**New Albany Planning Commission
March 4, 2024 Informal Meeting Minutes - Approved**

**Planning Commission Staff Report
March 4, 2023 Meeting**

**COURTYARDS AT HAINES CREEK SUBDIVISION
FINAL DEVELOPMENT PLAN**

404.616-01
February 20, 2024
(Revised 2/21/24)

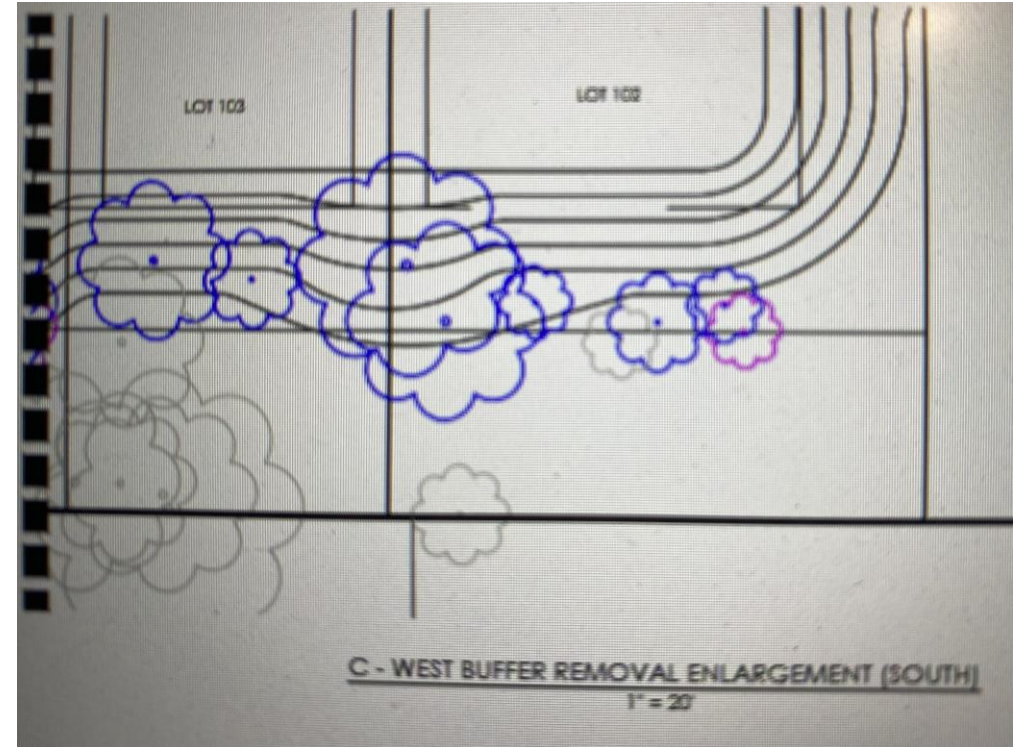
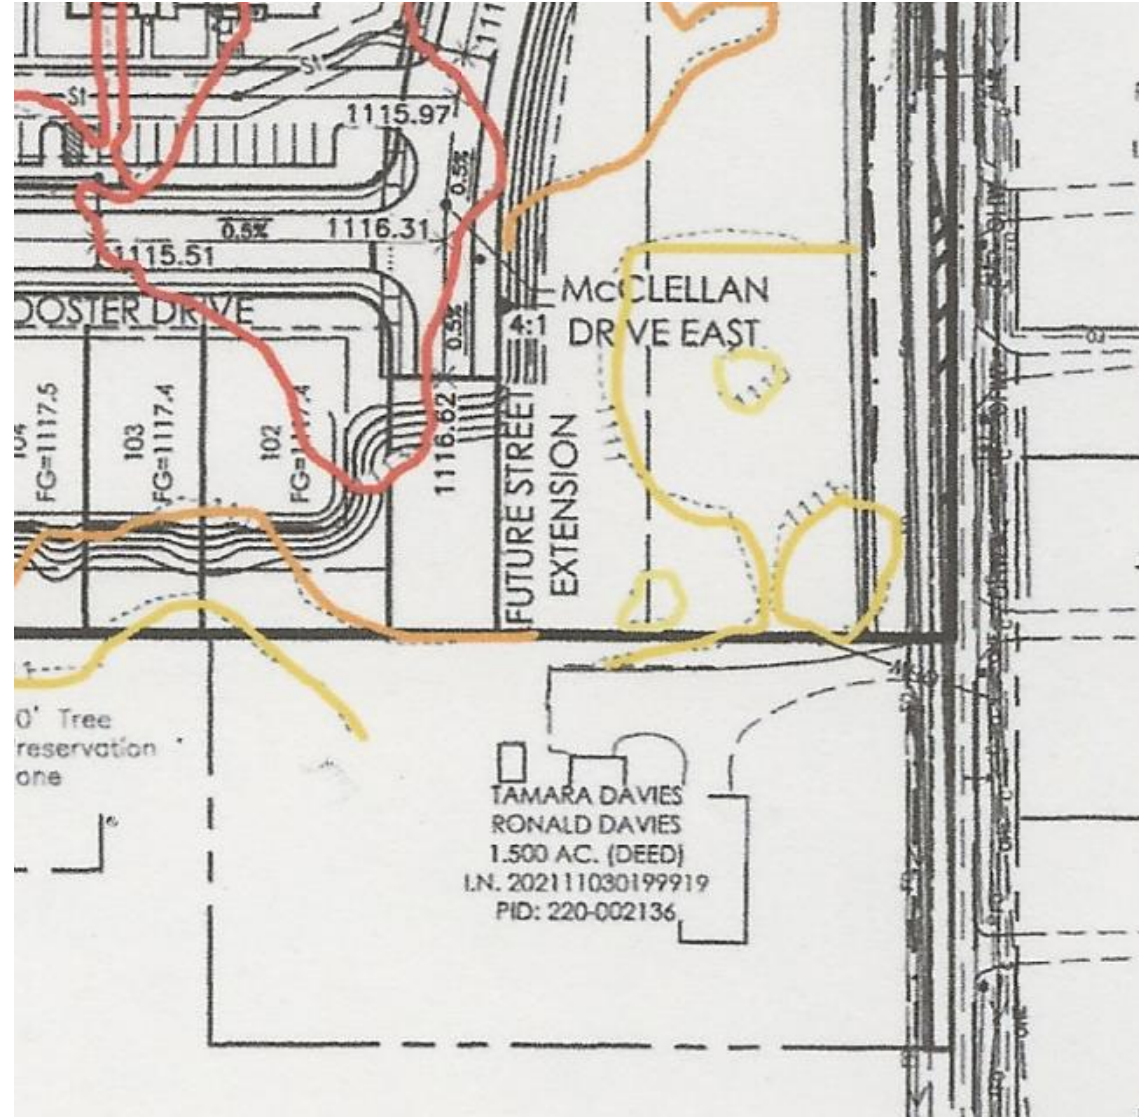
$158' \times 58' = 9164 \text{ft}^2$
 $1118 - 1110 = 8 \text{ft}$
 $9164 \text{ft}^2 \times 8 \text{ft} = 73312 \text{ft}^3$ or 2715 cubic yards

Dump truck load = 10 to 14 cubic yards

Therefore lot #113 will need 194 to 272 dump trucks full of dirt.

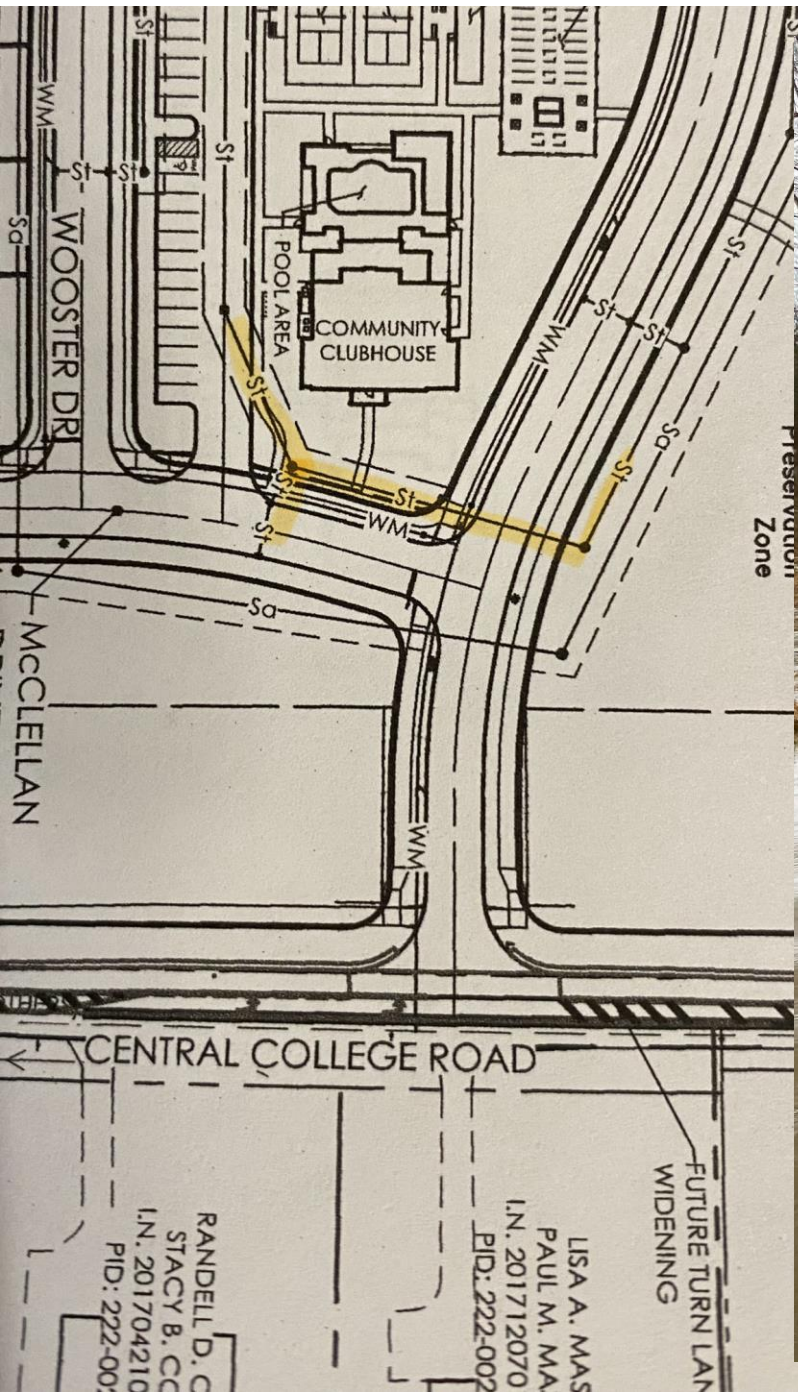
The home on lot# 102 will be 7 feet higher than the home at 8238 Central College Rd

The road stub will be 7 feet above grade for our home at 8238 Central College Rd. This disparity negatively effects the home's value.

Woodland Protections

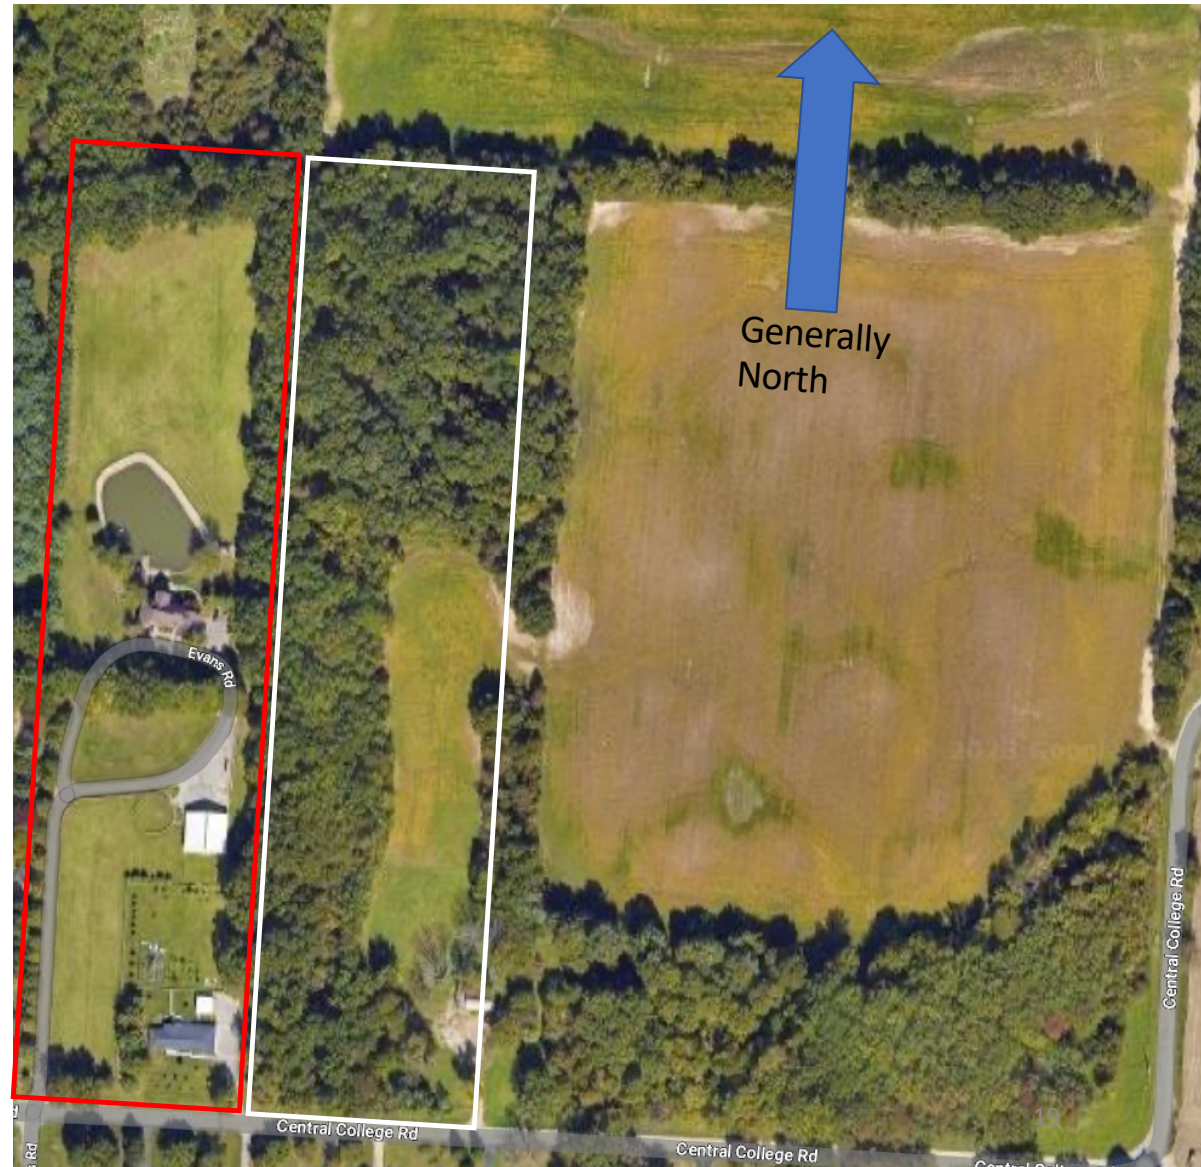
- Red Box ~11 acres
- White box – same size as red box.
- Applicant wants to clear cut majority of trees in the white box.
- Current plan does not retain substantial woodlands

Applicant's "Site Context" – from City Council MTG

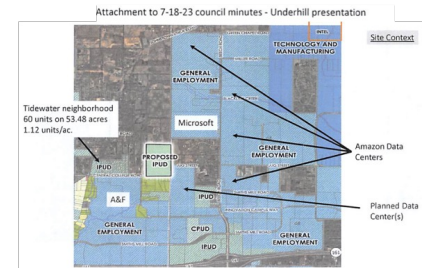
- Attachment to 7-18-2023 Council minutes
- Within this "Context" – there is not a single park with playground equipment.
- Applicant is asking to build 151 homes – with no playgrounds.
